City of Portland, Maine – Building or Use Permit Application 389 Congress Street, 04101, Tel: (207) 874-8703, FAX: 874-8716

Location/Address of Construction: 930 FOREST AVENUE - PORTLAND 04103

DATE: 5 DEC, 98 ADDRESS: 930 Forest Ave. CBL 142-E-004
REASON FOR PERMIT: To Construct a 12'x15' breezeway w/ 1/2 bath: 4'x4'10"
BUILDING OWNER: Eva Kelley
CONTRACTOR: Guy Raymond
PERMIT APPLICANT: owner
USE GROUP R-3 BOCA 1996 CONSTRUCTION TYPE 5B

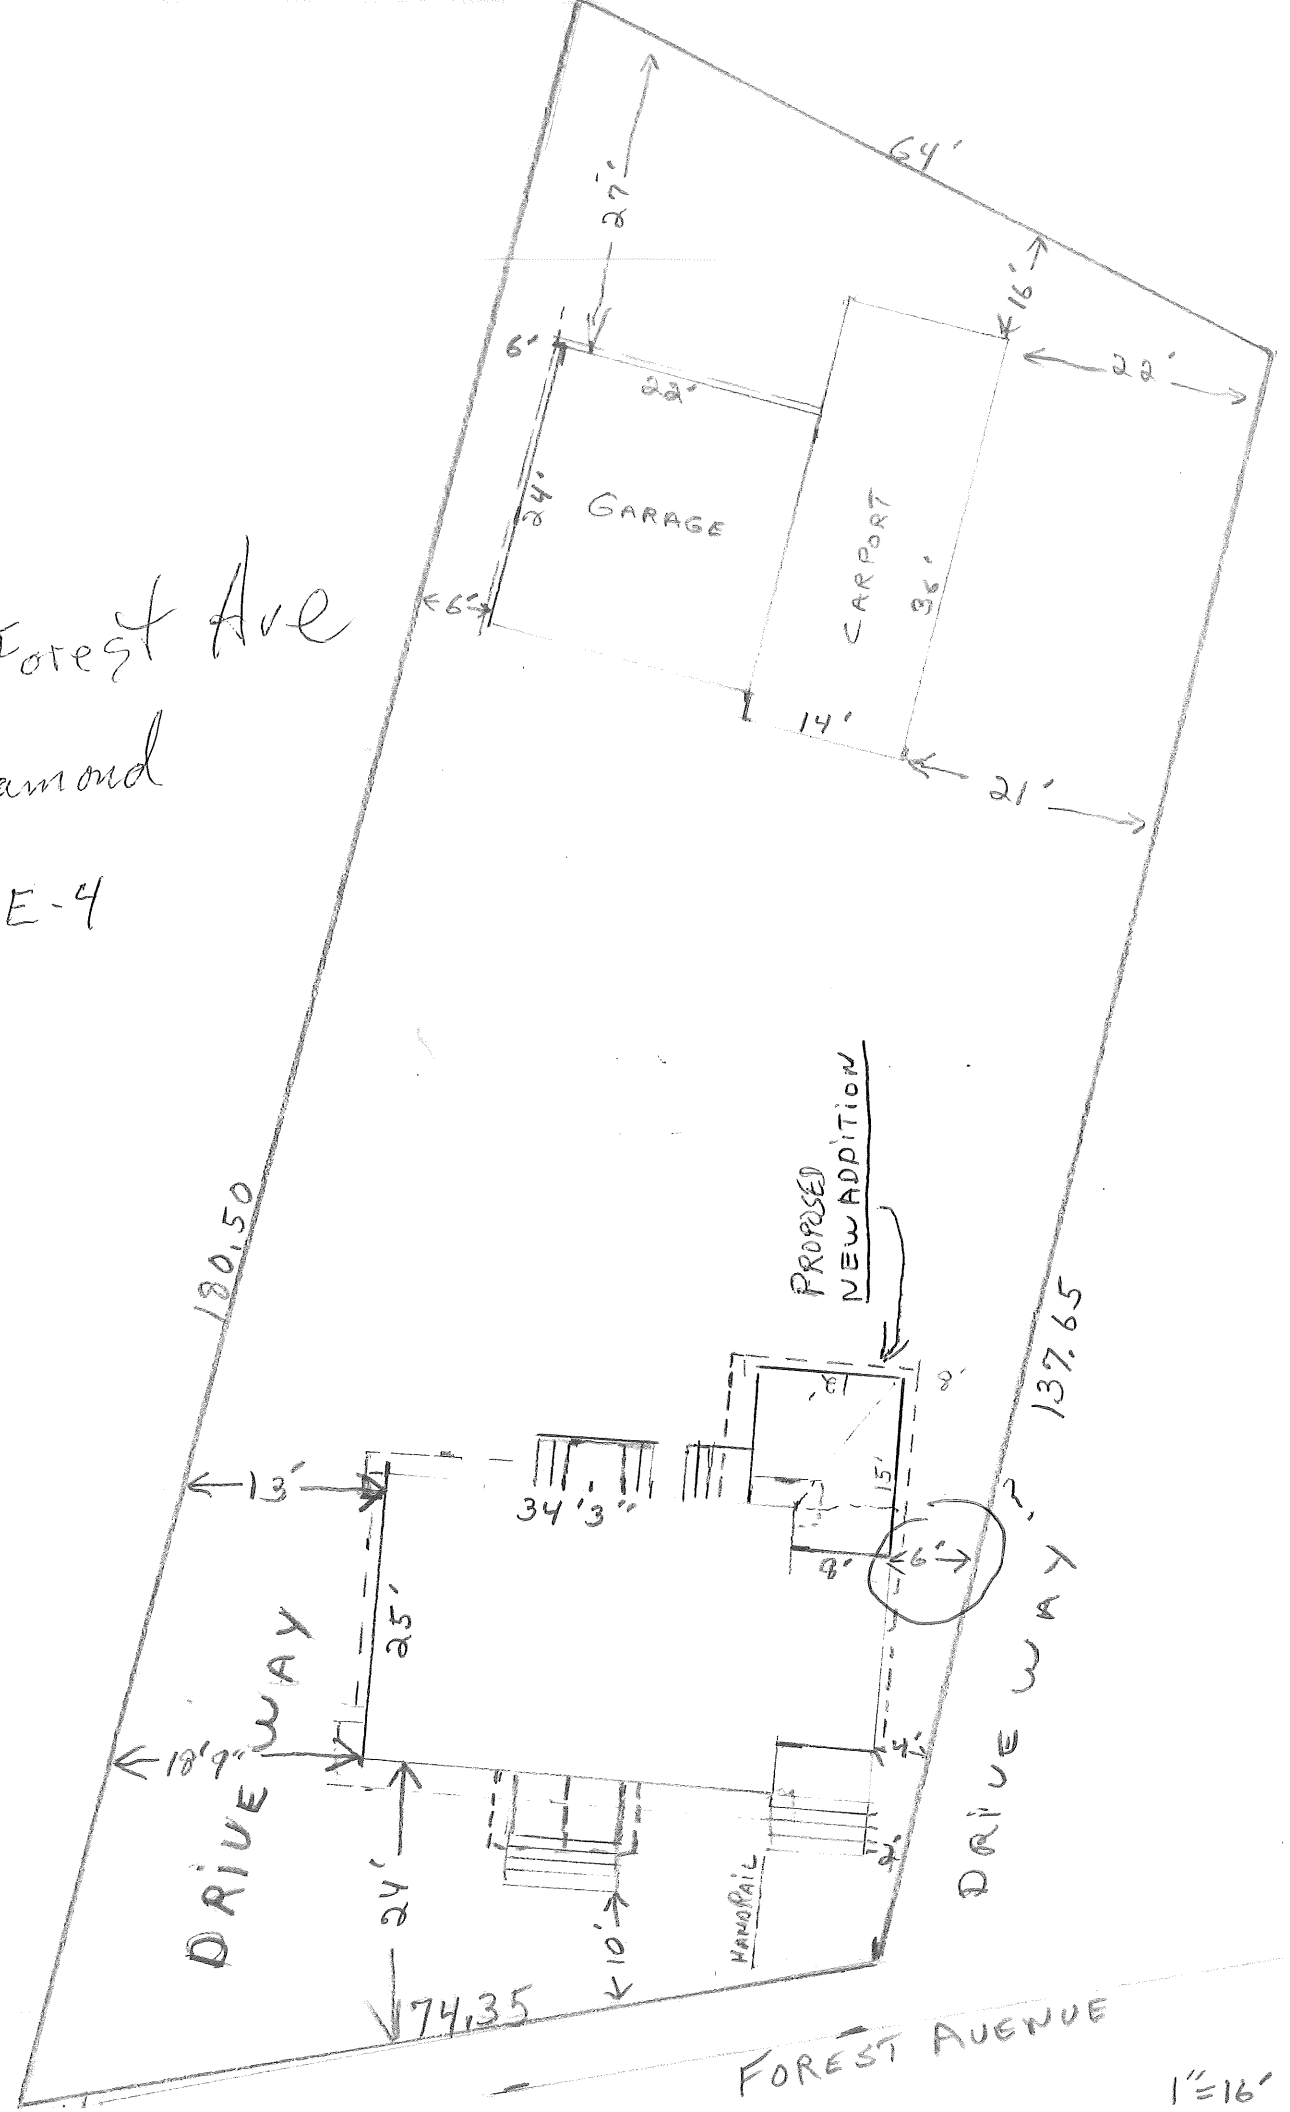
This building permit is being issued with the understanding that a revised Framing plan must be submitted for approval before work is started - Your foundation system does not and your floor framing system does NOT meet the bldg code requirements - Footing need needed under piers - The 2x10" raftering diagonally from existing bldg. to foundation pier with floor joist system attached is under designed - Please call me on these matters. Also your proposed 2x10" hip rafter is being MAX. out with live and dead loads -

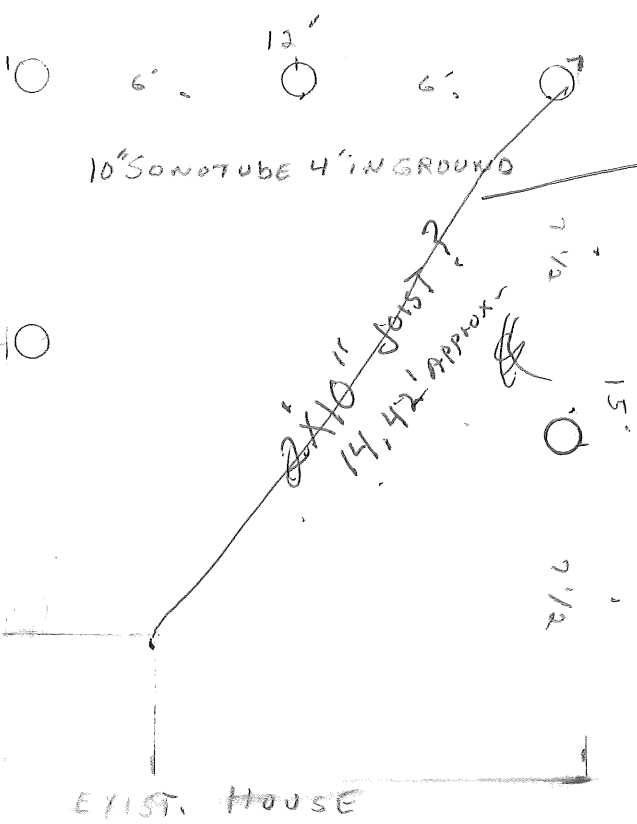
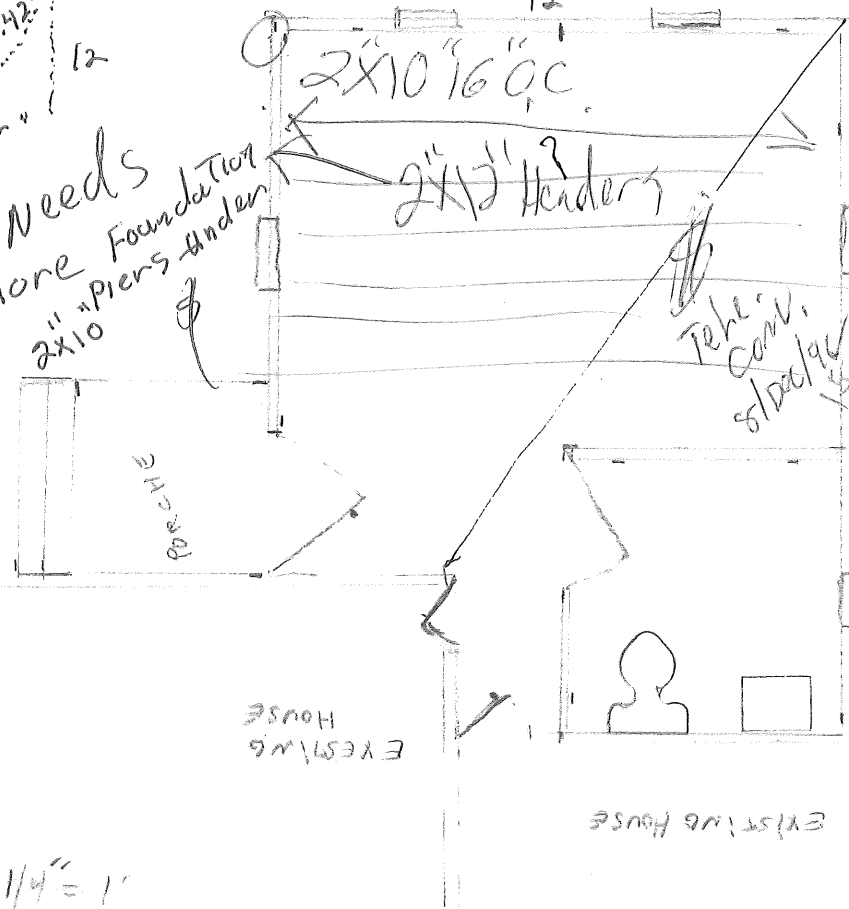
$7^2 + 10^2 = C^2$
 $49 + 100 = C^2$
 $149 = C^2$
 $C = 12.2$

Needs More Foundation
 2x10 Piers Under
